ADDENDUM No. 1
Request for Competitive Sealed Proposals (CSP)
19CSP085- Renovations at Casey Elementary

CASEY ELEMENTARY SCHOOL
RENOVATIONS AT CASEY ELEMENTARY SCHOOL

ADDENDUM NO. 01: December 21, 2018

Sheet: **M9.1**

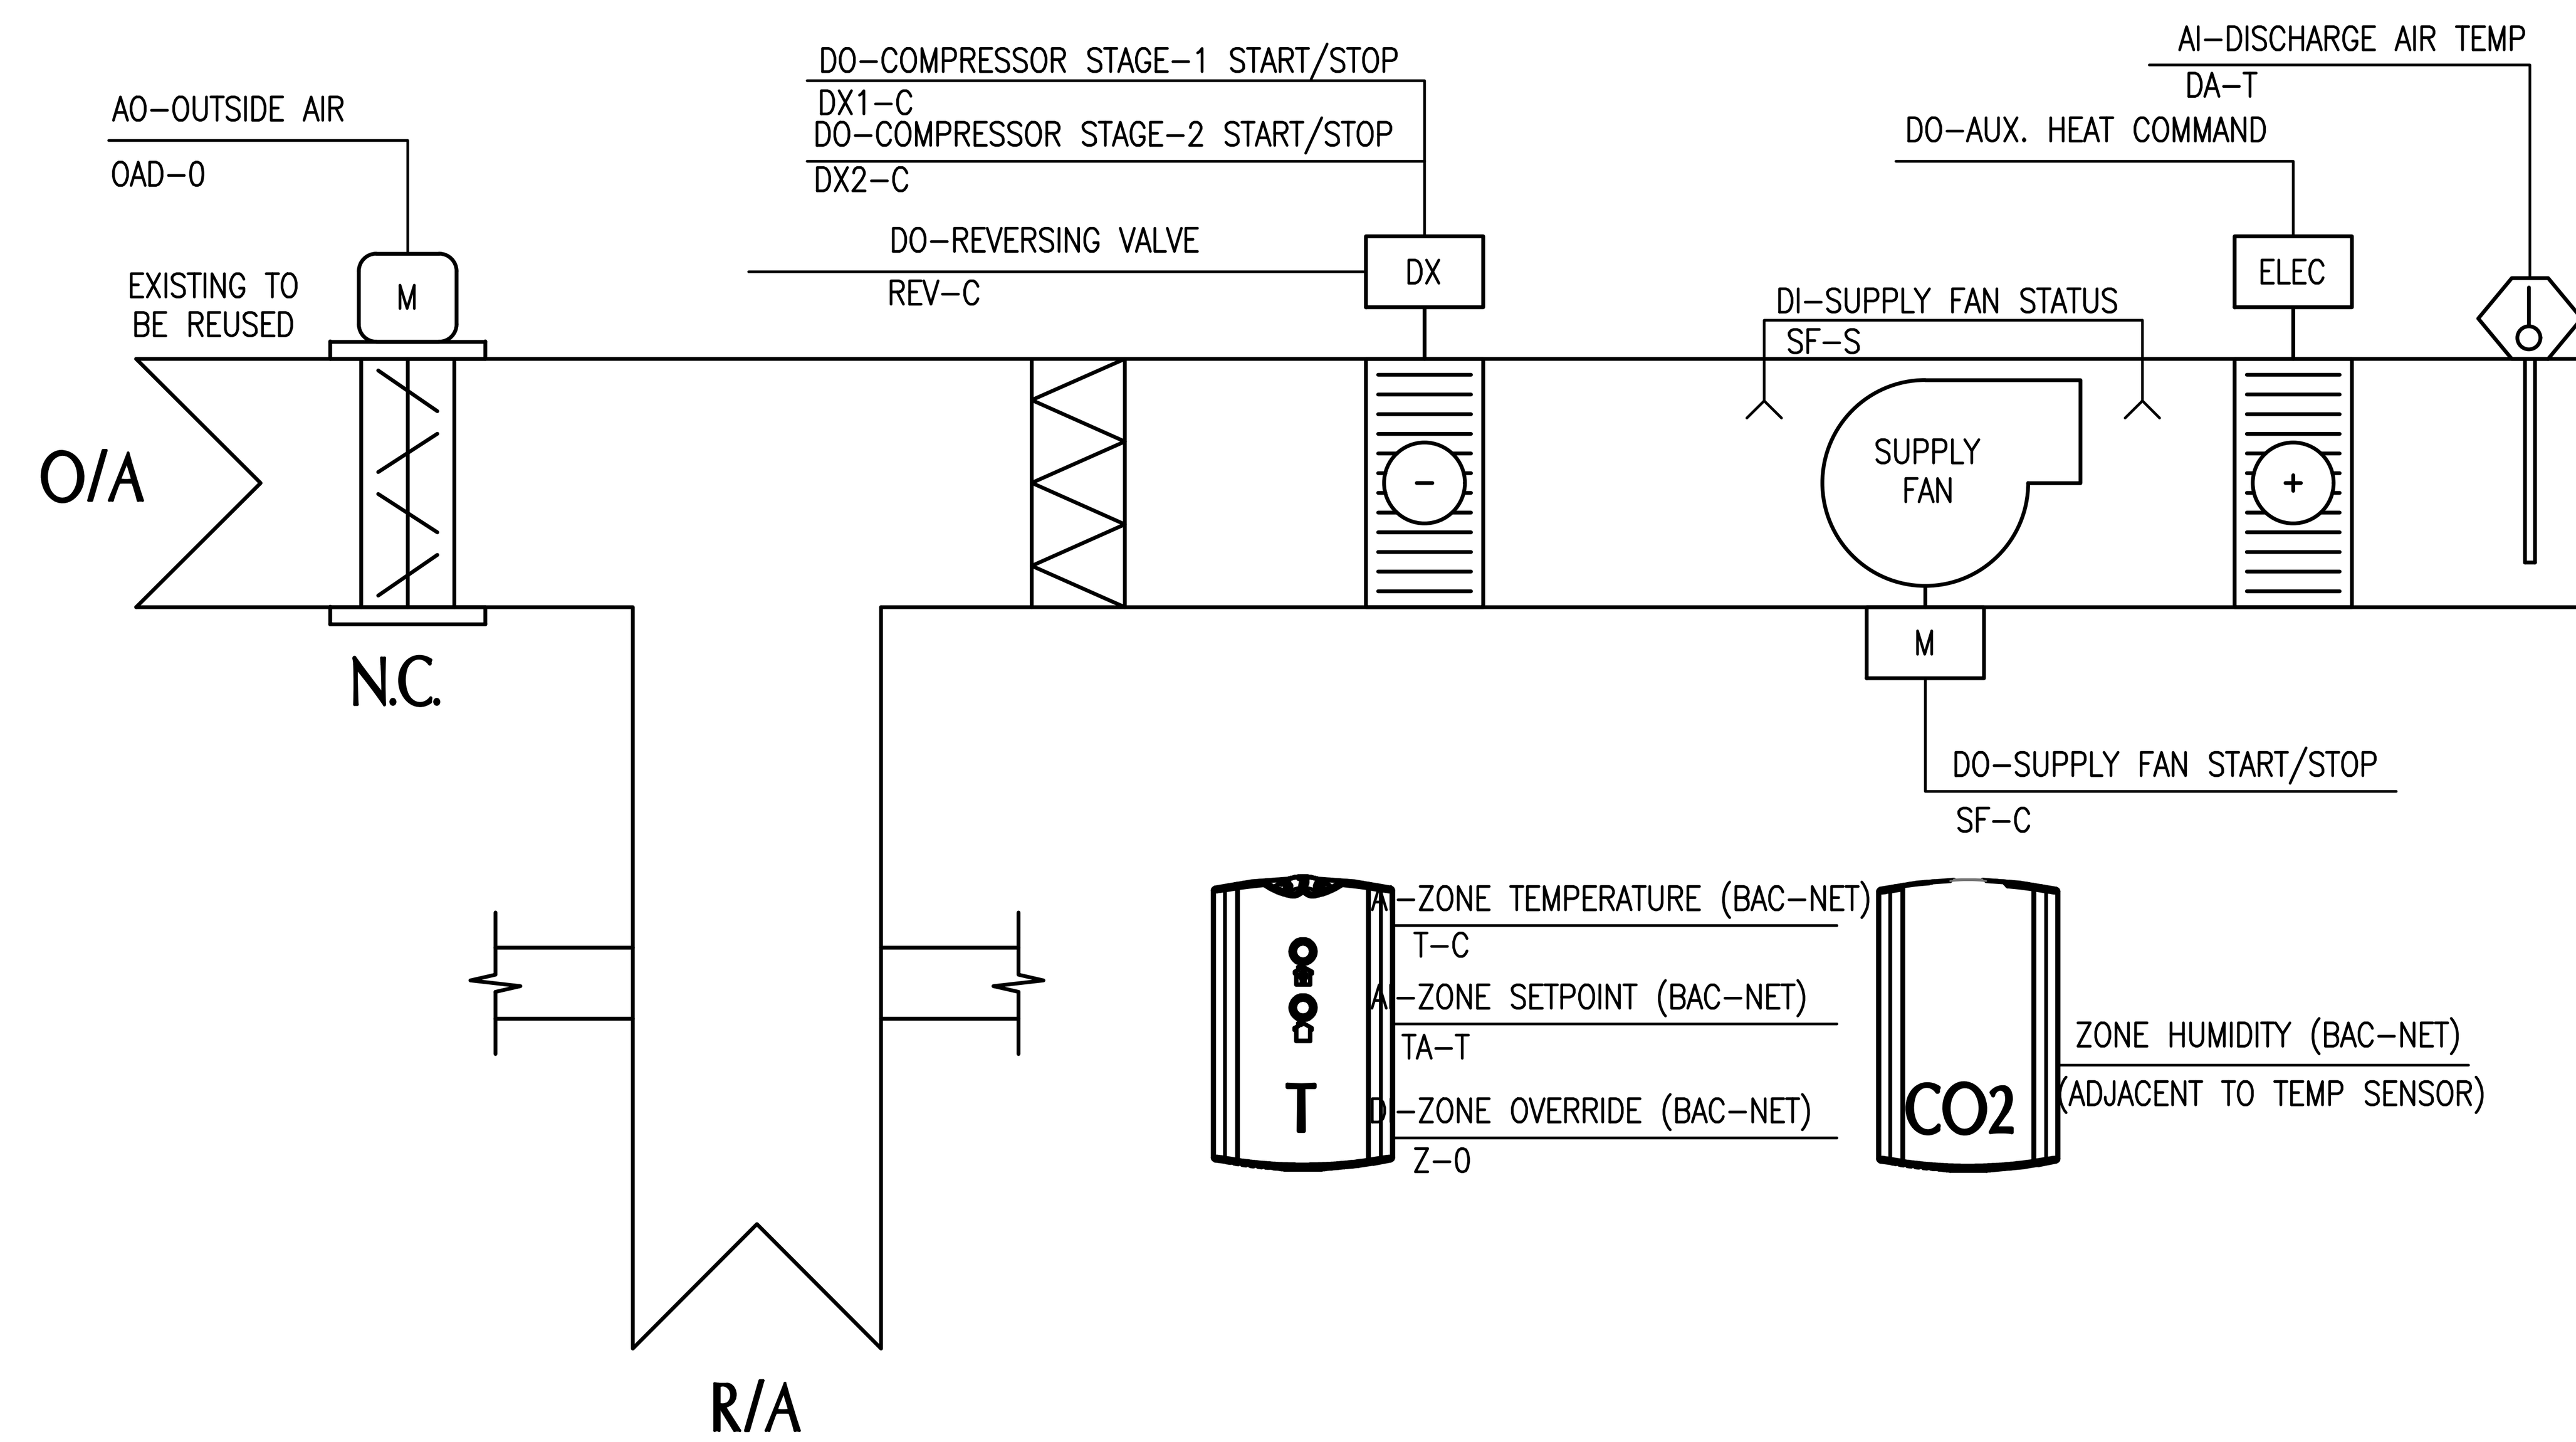
11. M9.1
    Revised to indicate outside air flow station.

1 FIRST FLOOR ELECTRICAL DEMOLITION PLAN
E1.2 SCALE: 1/8"=1'-0"

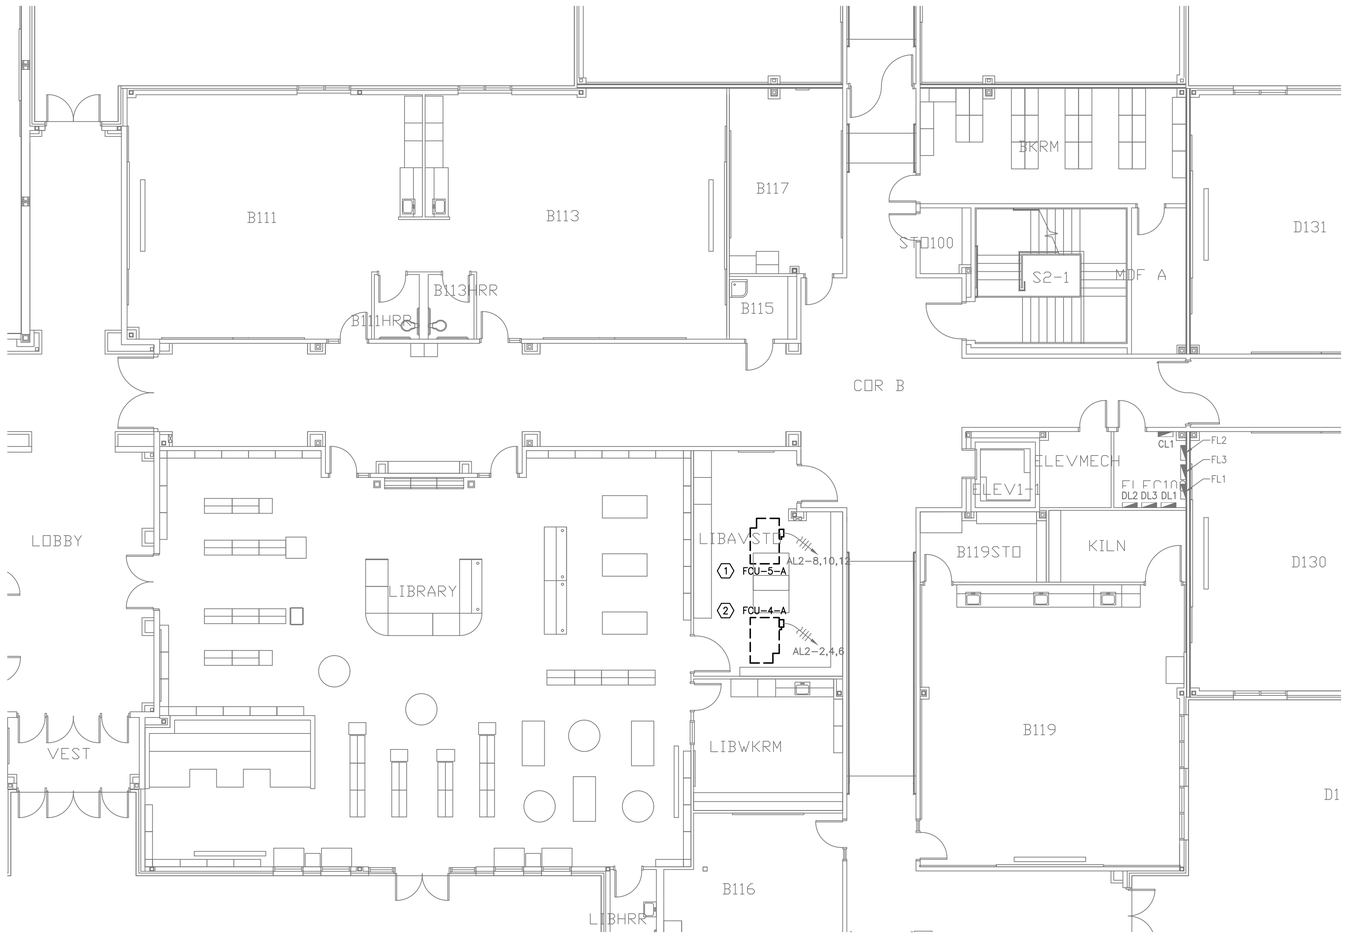
1. Sheet E1.2:
   Notes were updated to instruct the electrical contractor to re-use the existing raceways and conductors.

1. ① DISCONNECT EXISTING ELECTRICAL ASSOCIATED WITH EXISTING FAN COIL UNIT FCU-5-A. EXISTING RACEWAYS AND CONDUCTORS TO BE RE-USED AS REQUIRED.
2. ② DISCONNECT EXISTING ELECTRICAL ASSOCIATED WITH EXISTING FAN COIL UNIT FCU-4-A. EXISTING RACEWAYS AND CONDUCTORS TO BE RE-USED AS REQUIRED.

1 E2.1 FIRST FLOOR ELECTRICAL REVISED PLAN
SCALE: 1/8"=1'-0"

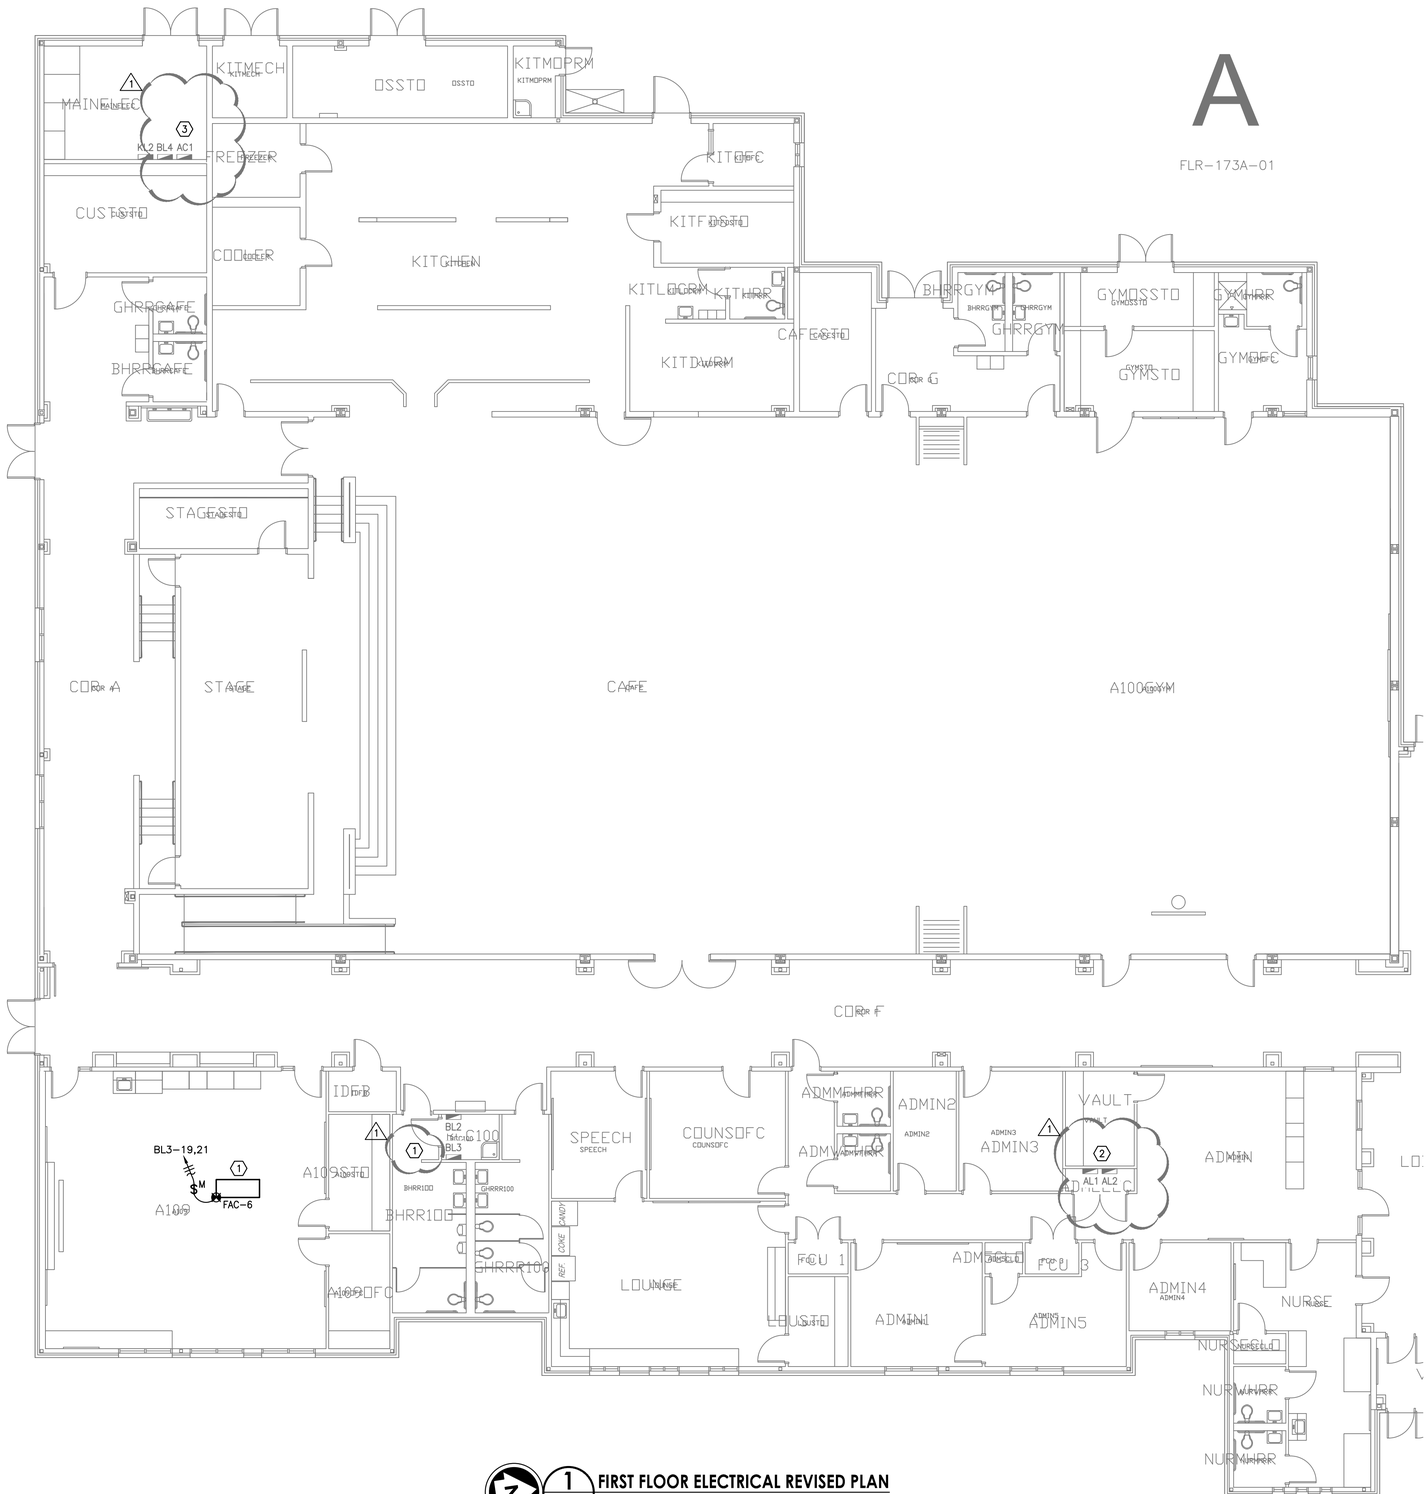
2. Sheet E2.1:
   Notes were updated to make the locations of panels AL2 and AC1 were located.

1. ELECTRICAL CONTRACTOR SHALL CONNECT NEW FAN COIL UNIT FAC-6 TO EXISTING PANEL BL3 LOCATED ELECTRICAL ROOM AS SHOWN. PROVIDE AND INSTALL 1"C W/2#6, 1#10G FROM PANEL BL3 TO NEW FAN COIL UNIT.
2. LOCATION OF EXISTING PANEL AL2.
3. LOCATION OF EXISTING PANEL AC1.

1 FIRST FLOOR ELECTRICAL REVISED PLAN
E2.2 SCALE: 1/8"=1'-0"

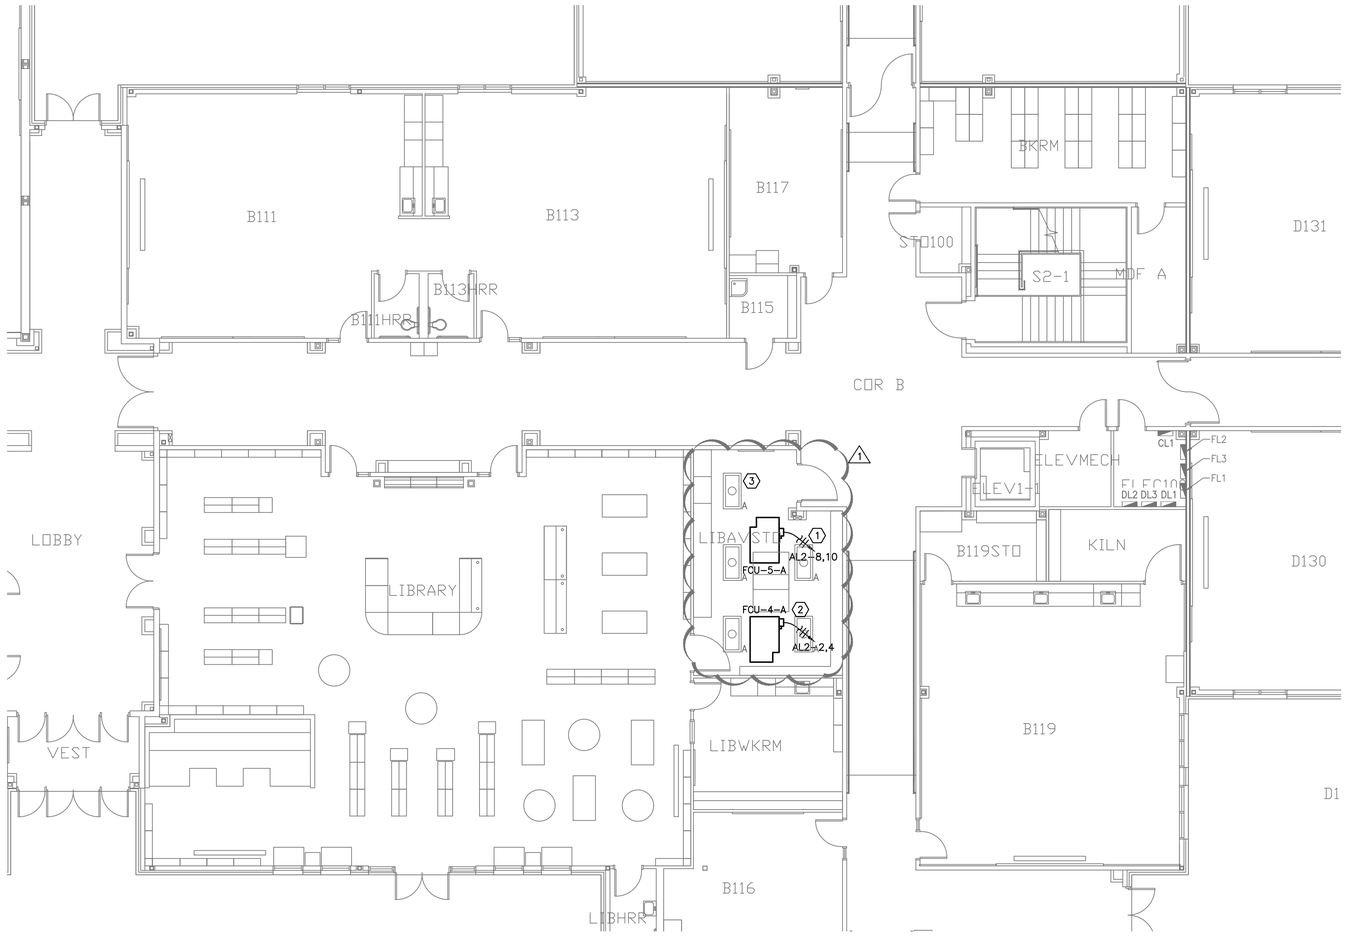
3. Sheet E2.2:
   Drawings and Notes were updated to show and instruct the electrical contractor to disconnect and re-install existing 2x4 fixtures in the area of work.

1. ELECTRICAL CONTRACTOR SHALL CONNECT NEW FAN COIL UNIT FCU-5-A TO EXISTING PANEL AL2 LOCATED ELECTRICAL ROOM AS SHOWN. UTILIZE EXISTING CONDUCTORS AND RACEWAYS AS REQUIRED.
2. ELECTRICAL CONTRACTOR SHALL CONNECT NEW FAN COIL UNIT FCU-4-A TO EXISTING PANEL AL2 LOCATED ELECTRICAL ROOM AS SHOWN. UTILIZE EXISTING RACEWAYS AND CONDUCTORS AS REQUIRED.
3. ELECTRICAL CONTRACTOR SHALL RE-INSTALL EXISTING 2X4 LIGHT FIXTURES IN ROOM AS REQUIRED. TYPICAL.

1 E2.3 **SECOND FLOOR ELECTRICAL REVISED PLAN**
SCALE: 1/8"=1'-0"

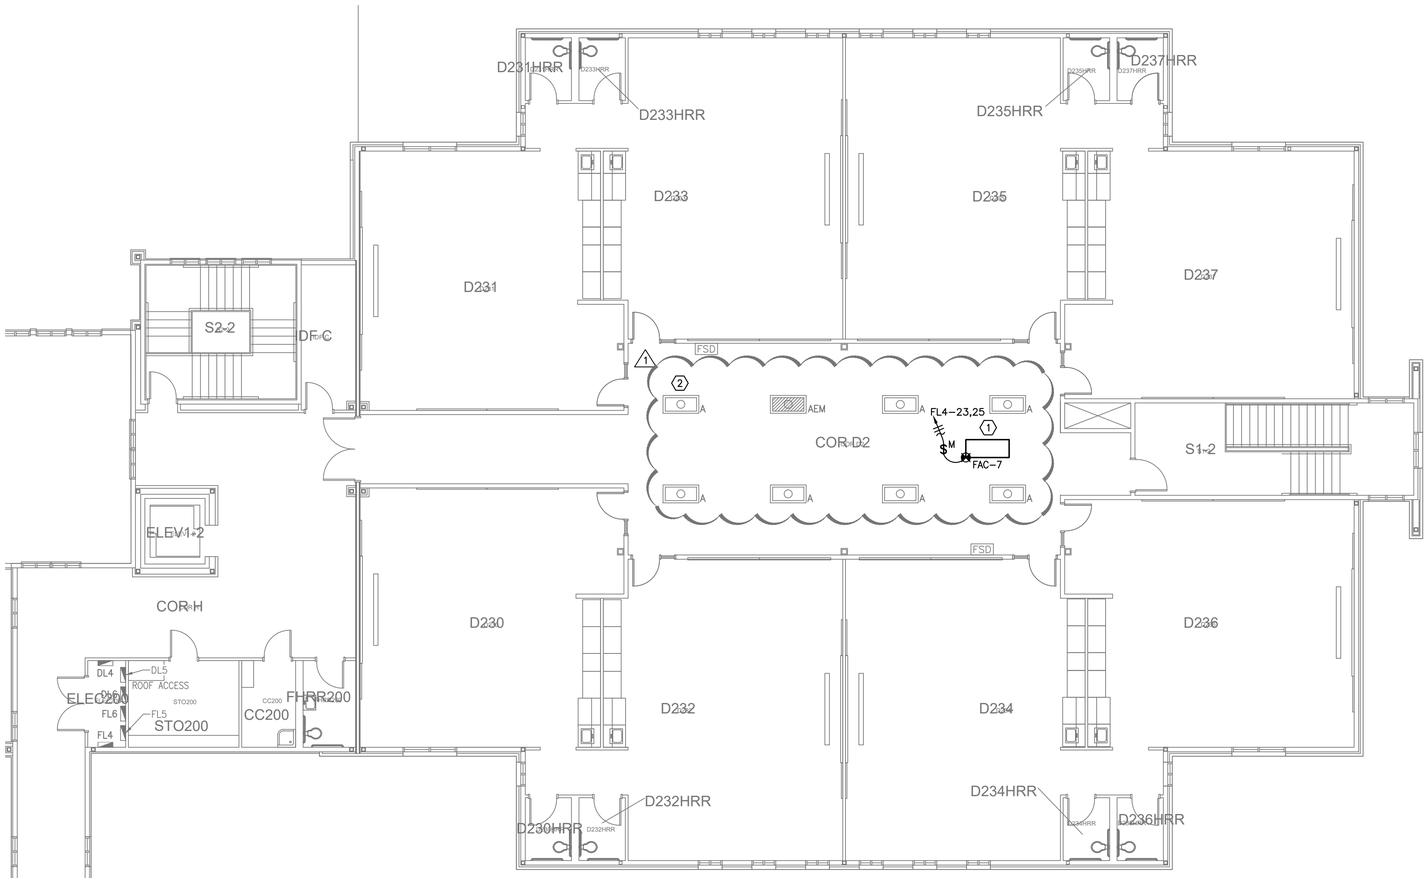
4. Sheet E2.3:
   Drawings and Notes were updated to show and instruct the electrical contractor to disconnect and re-install existing 2x4 fixtures in the area of work.

1. ELECTRICAL CONTRACTOR SHALL CONNECT NEW FAN COIL UNIT FAC-7 TO EXISTING PANEL FL4 LOCATED ELECTRICAL ROOM AS SHOWN. PROVIDE AND INSTALL 3/4"C W/2#8, 1#10G FROM PANEL FL4 TO NEW FAN COIL UNIT.
2. ELECTRICAL CONTRACTOR SHALL RE-INSTALL EXISTING 2X4 RECESSED LIGHT FIXTURES IN ROOM AS REQUIRED. TYPICAL.
